PICTORIAL 10-1

## HW-5400 TRANSCEIVER MODIFICATIONS COMPLETE LIST

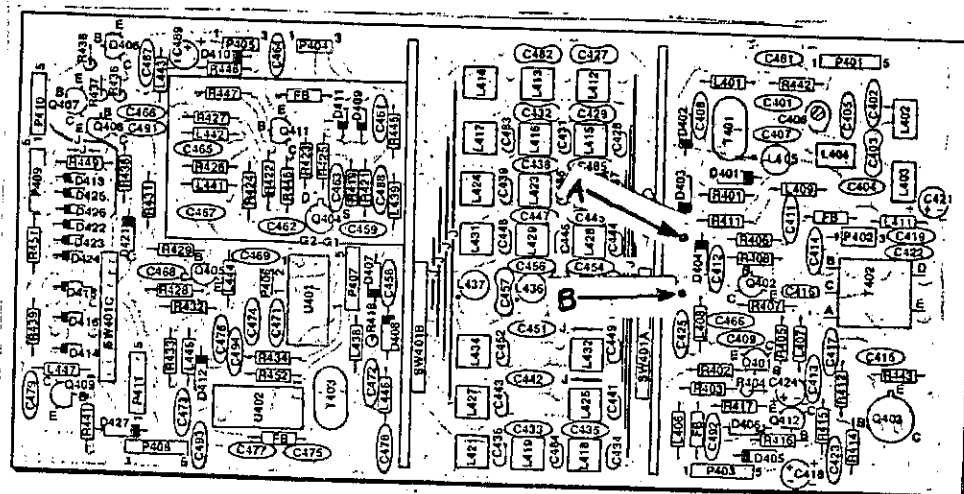
#56-648 DIODE NO LONGER AVAILABLE

The HV109 varactor diodes at D101, D301, D351, D701, and D701B are changed:

From #56-648 to #56-674.

This new diode is an MV209 and has a different case style. Install it as shown at the right. Use this new diode when a replacement is needed.

( ) D701B: MV109 diode (#56-648). There is no outline for this diode. Be sure to position the marked end as shown.

- 1. Add diode D701B as shown on the attached sheet. - Check this
- 2. Change C703 and C704 to 220 pF, part number 20-120.
- 3. Change Q701 and Q702 to part number 417-154.
- 4. Note .... DO NOT change C702 .... it should be 3.2 - 18 pF trimmer (blue screw) part number 31-71.
